Wollongong Local Planning Panel Assessment Report | 2 July 2020

WLPP No.	Item No. 2
DA No.	DA-2019/1155
Proposal	Residential – demolition of existing dwelling and construction of dual occupancy and Subdivision - Torrens title - two lots
Property	31 Olympic Boulevarde, Port Kembla
Applicant	DeBu Studios
Responsible team	Development Assessment and Certification - City Centre Major Development Team (RW)

ASSESSMENT REPORT AND RECOMMENDATION

Figure 1: Comparison between design reported to Panel and revised plans.

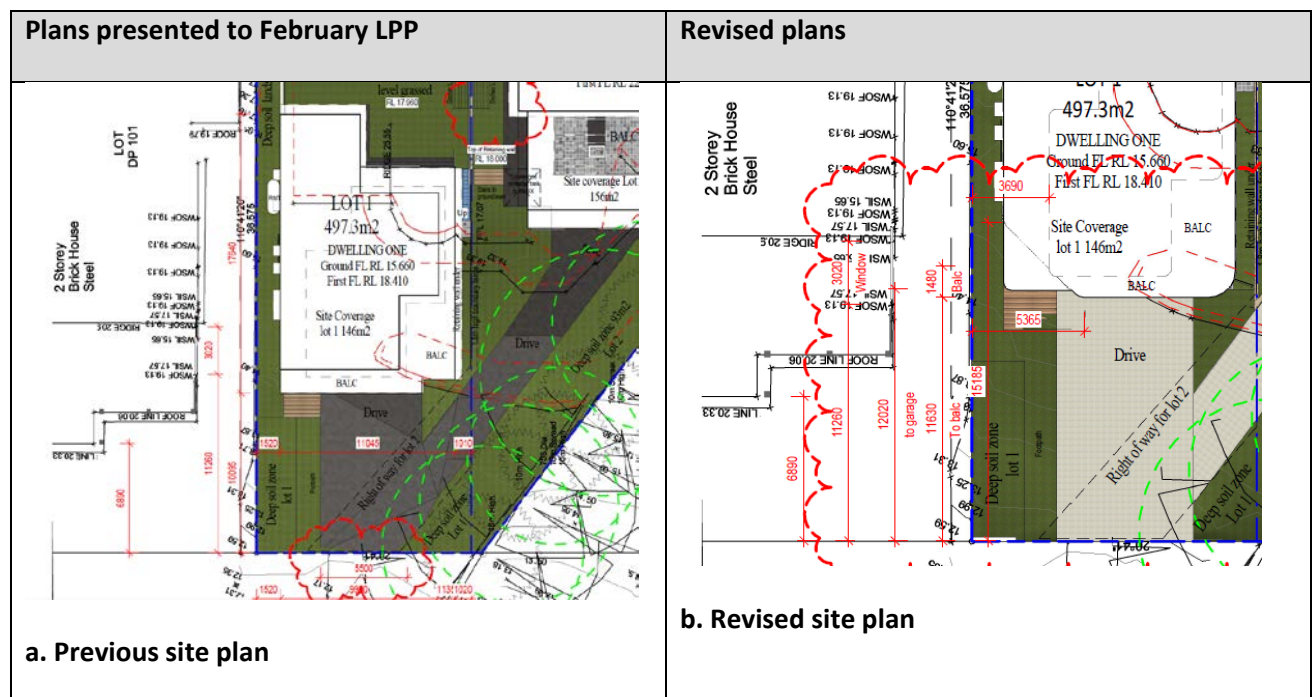
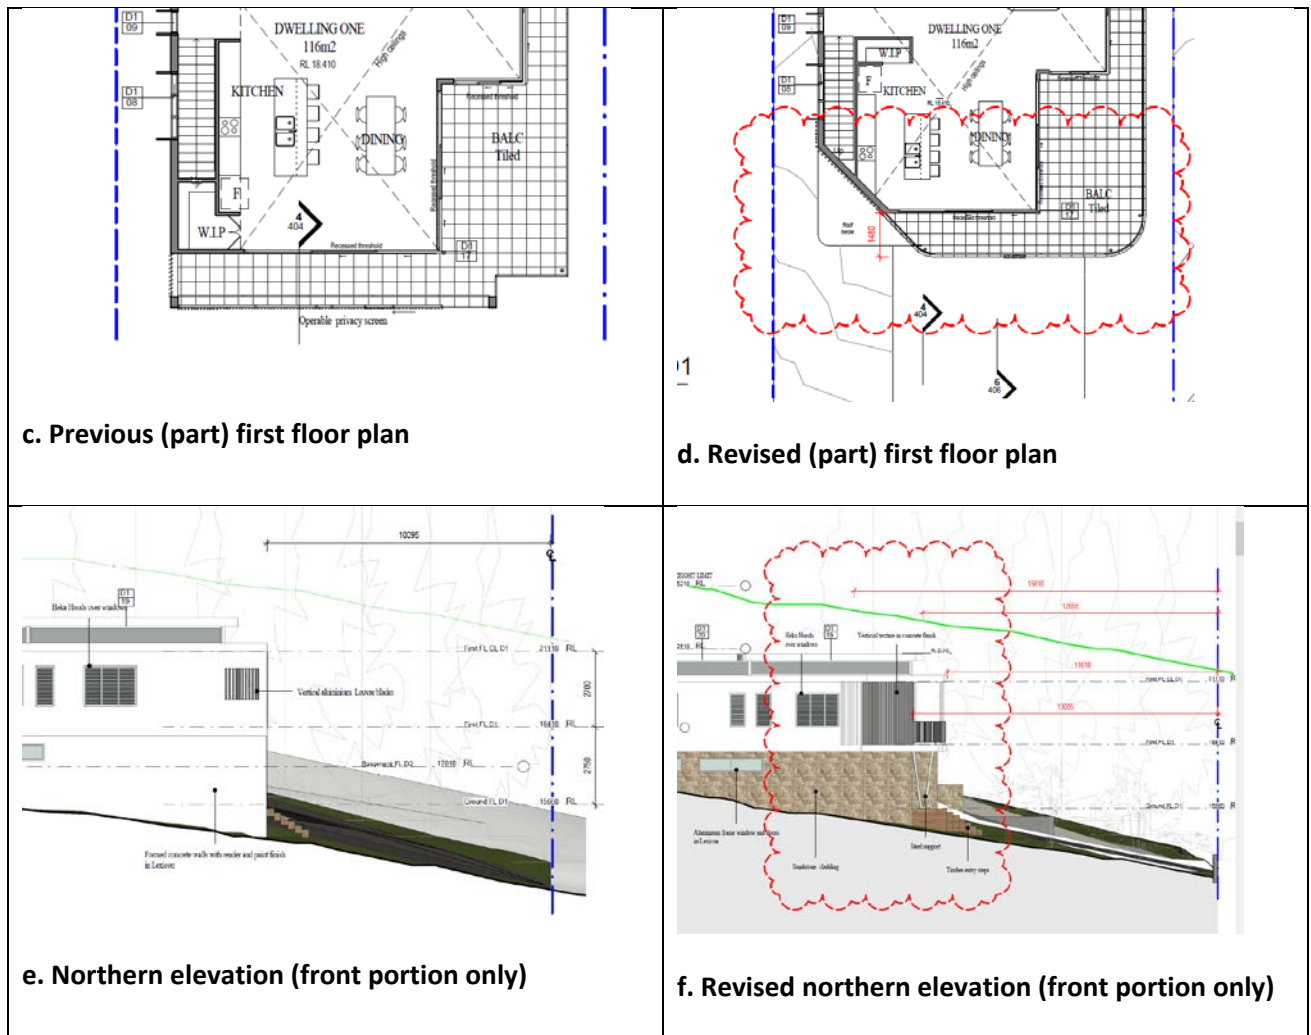
The revised plans have made the following changes to Dwelling 1:

- increased the front setback of the balcony by 1.535m (from 10.095m to 11.63m);
- a 45 degree splay has been introduced to the north-western corner;
- increase the setback of Dwelling 1's first floor façade to 13.09m at a distance of 3.69m from the northern boundary (due to splay);
- the privacy screen from the northern end of the balcony has been removed;
- the side setback of the first floor balcony from the northern boundary has been increased by a minimum of 2.19m from 1.5m to a setback of between 3.69m – 5.365m (due to splay design)

A comparison of the plans reported to WLPP and the revised design is shown below:

Figure 3: Southern elevation of 29 Olympic Boulevard showing room uses

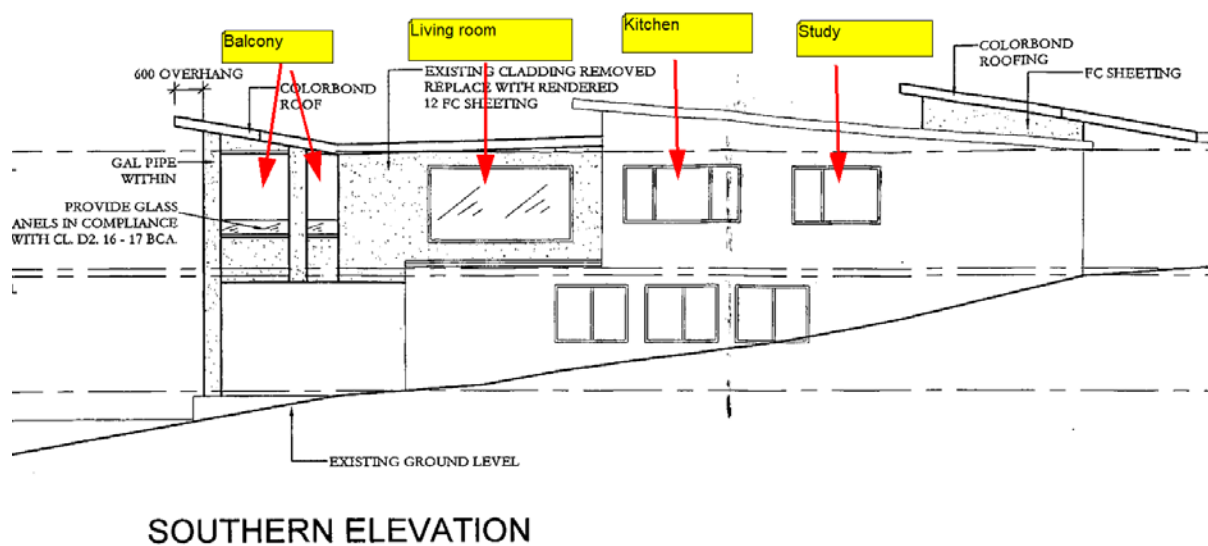
29 Olympic Boulevard has a front setback of 6m-8m to its balcony (steps in), 10m to the dwelling façade and 11.26m to the living room window, which is approximately 3m in length.

Figure 4: View looking from living room (taken from standing position in centre of living room as identified in Figure 6 of the addendum view analysis.

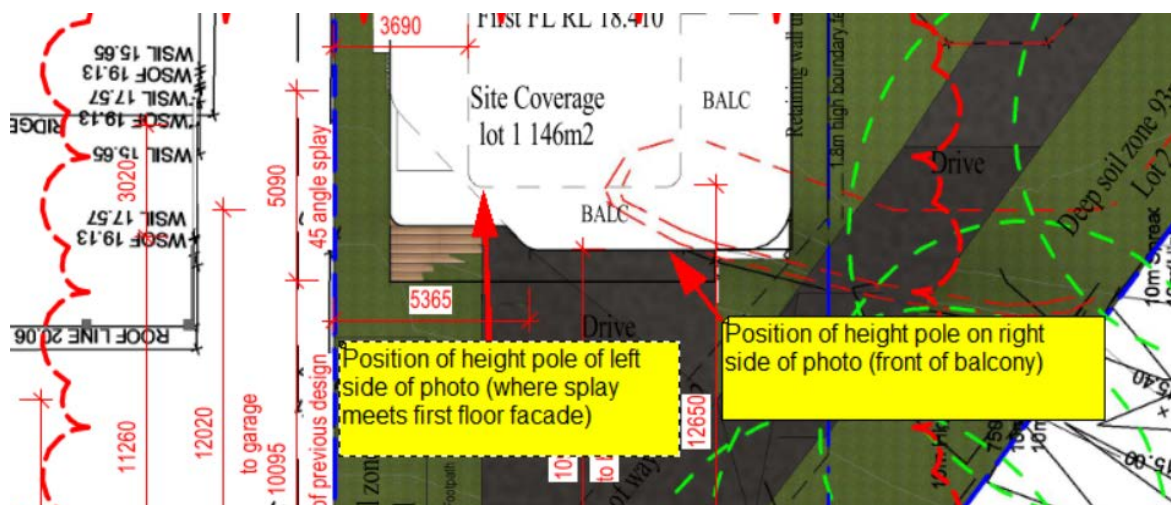
The windows on the southern elevation have views to the ocean, including the land-water interface. The large picture window shown below is the living room window from which expansive coastal views are currently available:

Notes a. The height pole on right shows location of proposed front balcony and height pole on left the first floor façade where it meets the splayed feature).

b. The balcony has since been reduced in width by increasing the setback to the front boundary a further 685mm from where the height pole is shown on the right.

Figure 10: excerpt from Drawing 701 with reduced balcony width and entry roof showing additional water views behind Tree 3 will be retained as viewed from a sitting position from the living room (refer Attachment 2 for full plan)

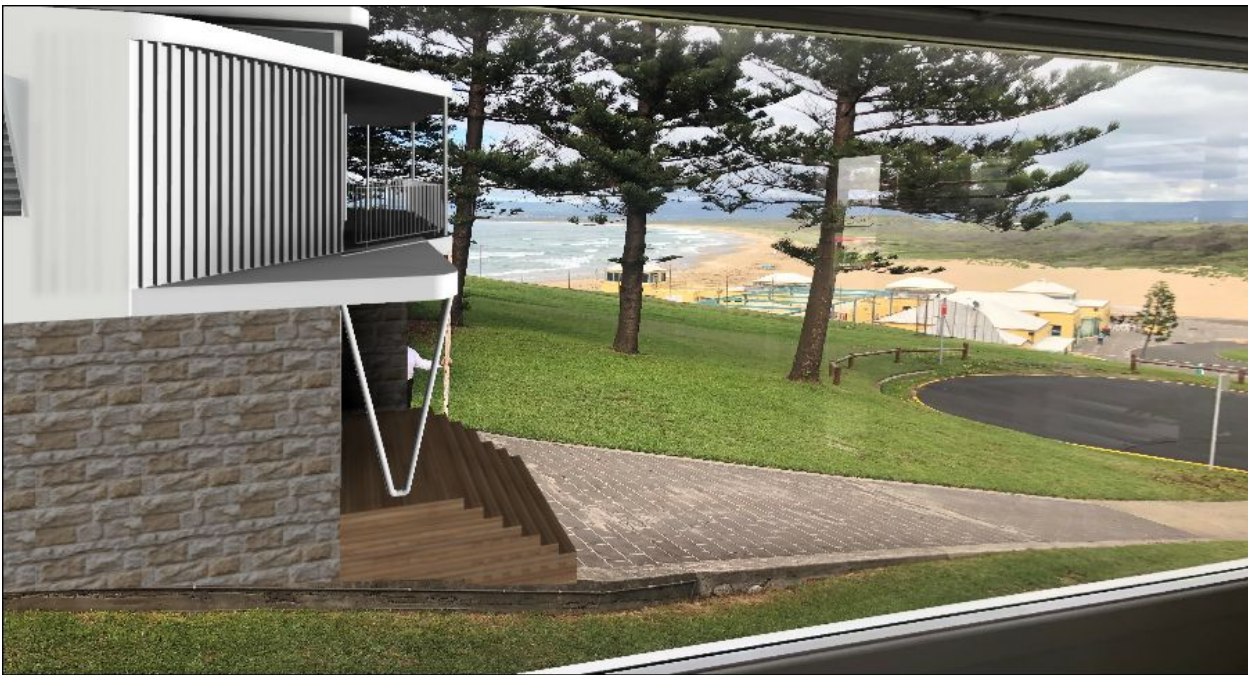
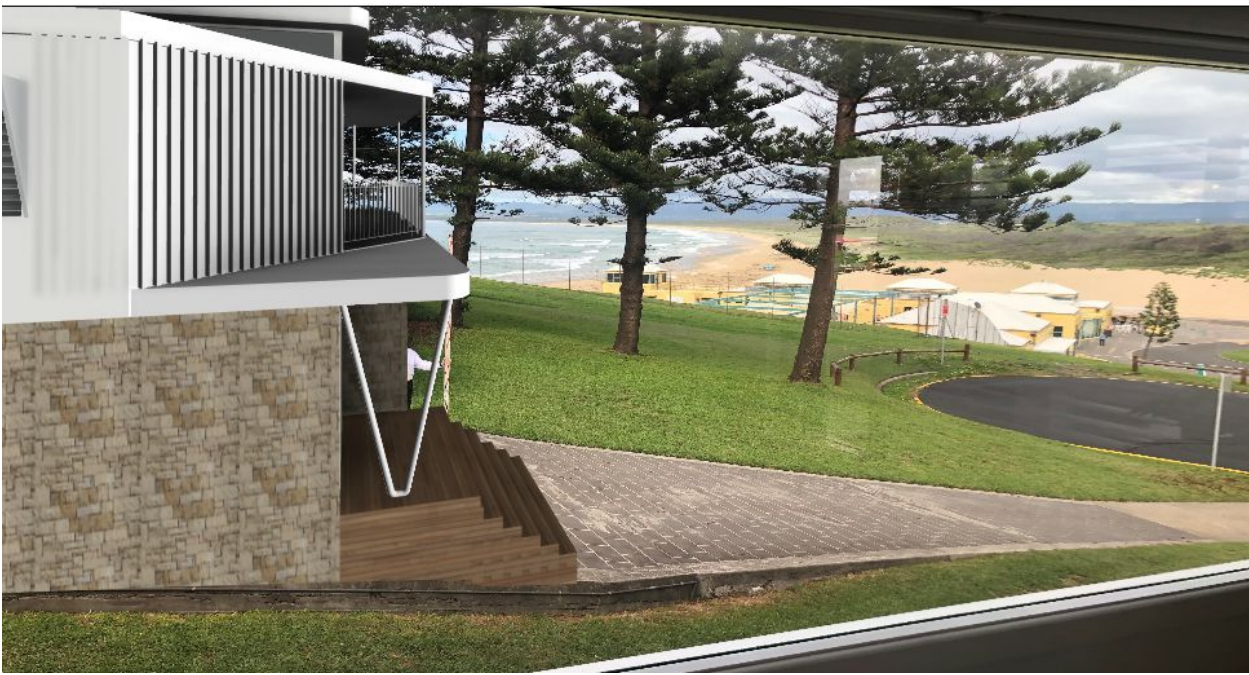
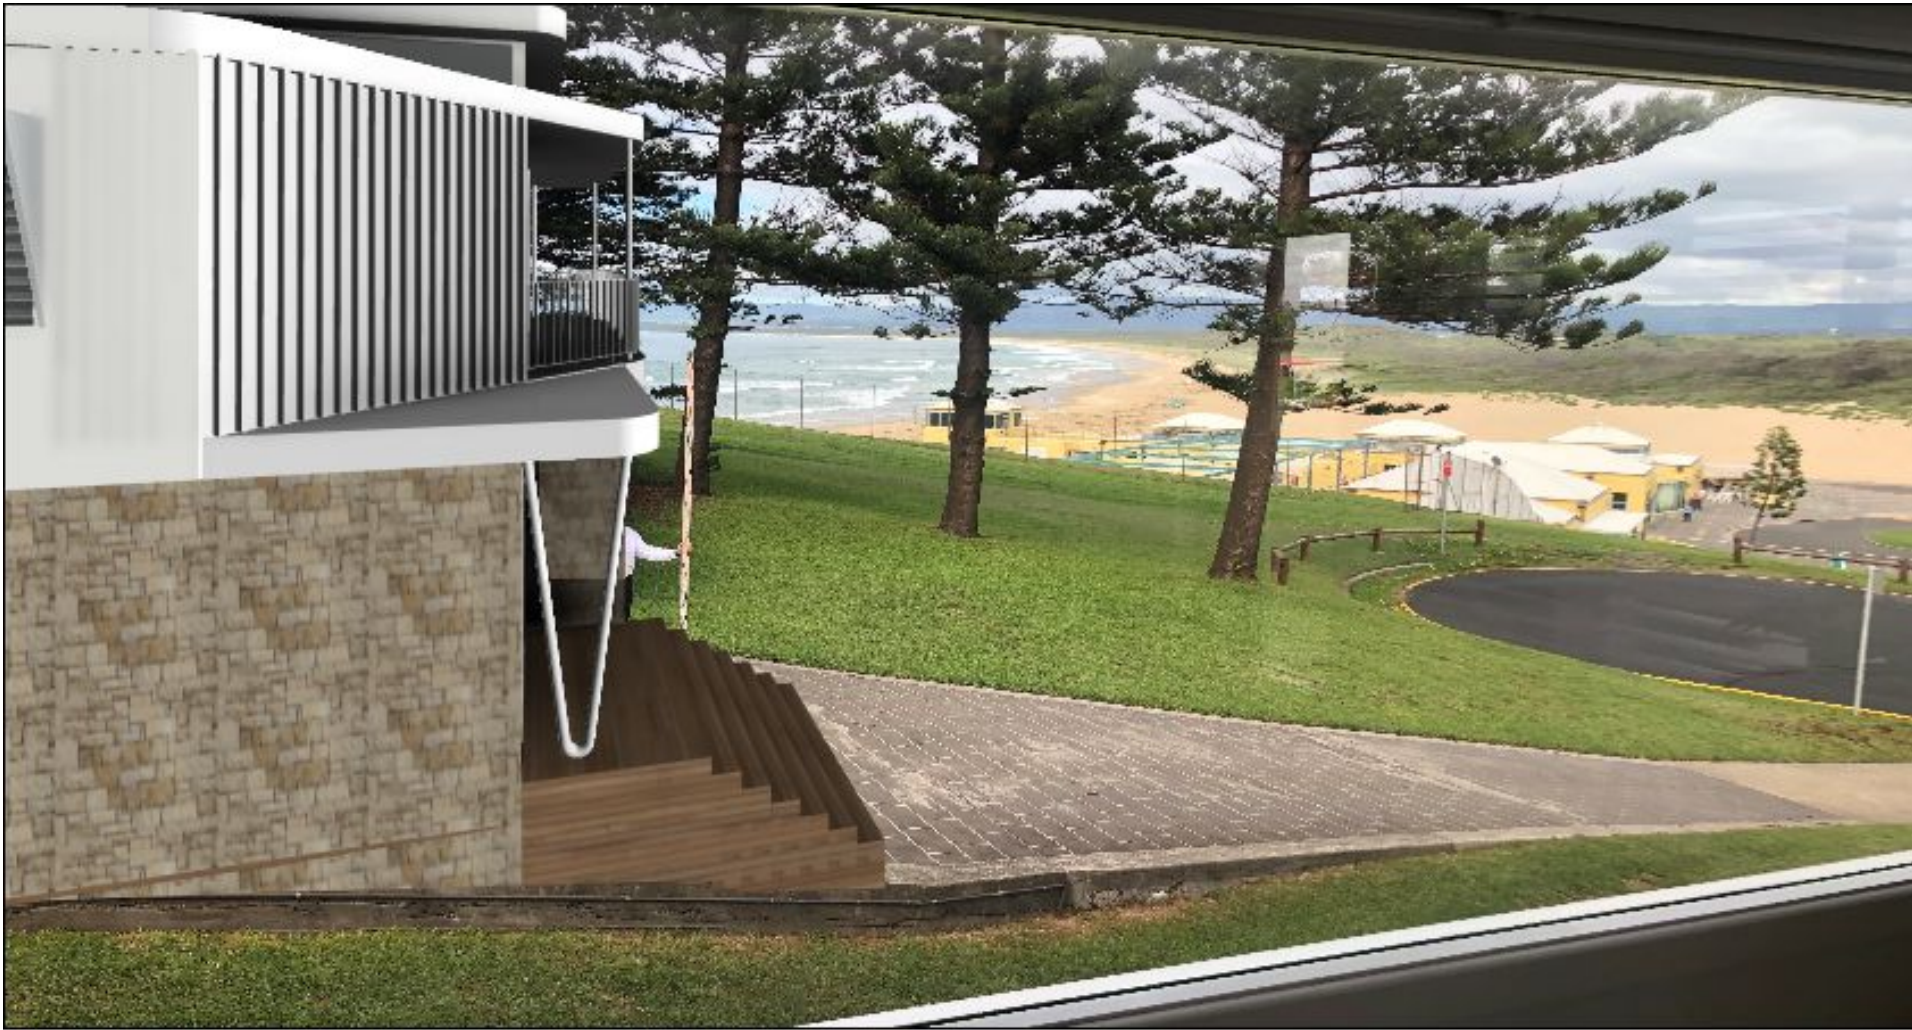
Dwelling 1's front balcony has since been reduced in width by increasing the front setback a further 685mm, noting that this minor increase to the balcony setback was not modelled in the full view analysis, however is shown in the photomontage submitted with the latest revised plans on 25 April 2020, as shown below:

The overall extent of the impact from the revised design could be assessed as moderate given that the majority of coastal views will be retained from the living room, including the land-water interface, however most coastal views will be lost from the kitchen which includes the land-water interface of Port Kembla beach.

Figure 1 – Relationship of the modified first floor plan of Dwelling 1 to the Living room window of No. 29 Olympic Boulevard.

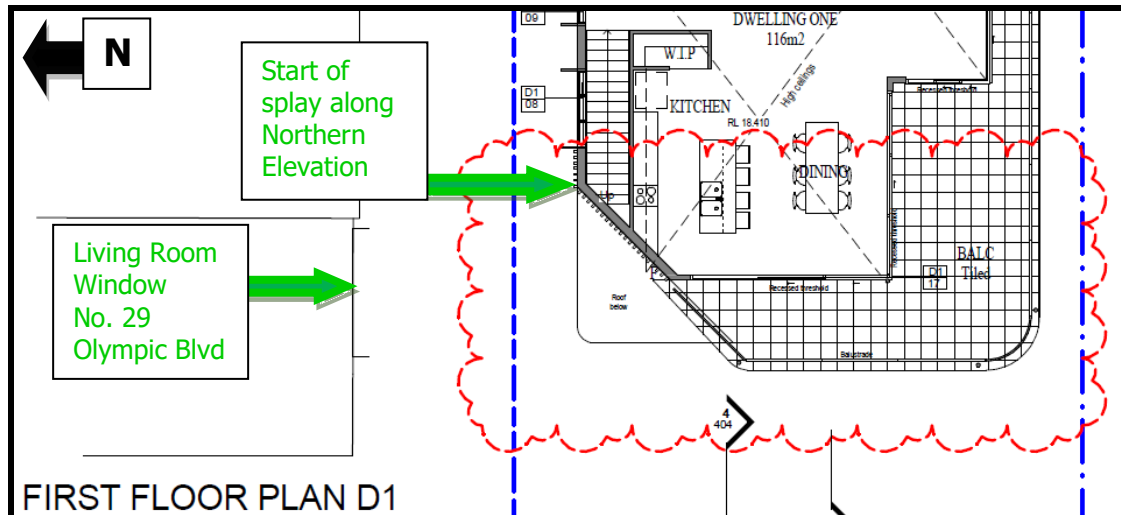
The below image demonstrates the manner in which the first floor, north-western corner of Dwelling 1 has been splayed from behind the Living room window of No. 29 Olympic Boulevard at an angle of 45degrees.

Figure 5 - This 3D image is overlaid on the above photo, showing the height pole lining up with the location and height of the front balcony in keeping with the plans provided to the CEH Consulting Pty Ltd.

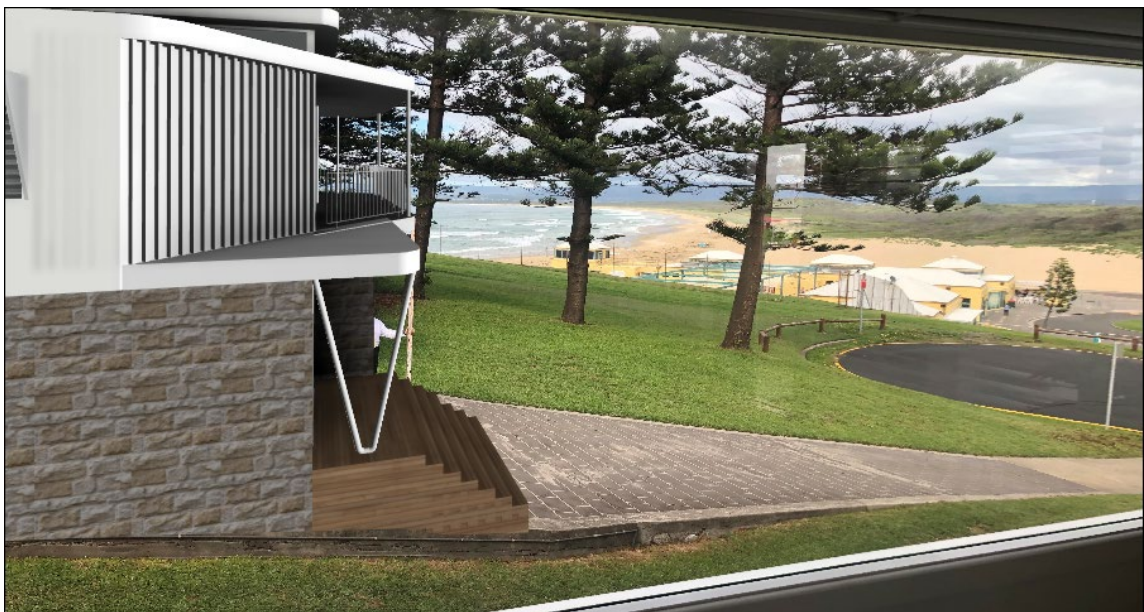
As can be seen in these images, the loss of water views resulting from the modified design is minimal due to the angle of the land to the south of No. 31. Viewed from this angle, being to the rear of the living room window, the front balcony will line up with the base of Tree 3 (with Tree 1 being closest to the road). The front façade commences approximately midway between Tree 3 & Tree 4.

Figure 5 above is considered to demonstrate the extent of the view that will remain available from a sitting position, across a side boundary. The image itself is taken from a standing position, however as the front setback (rather than height) determines the extent of the view, the standing and sitting views will remain of a similar context.
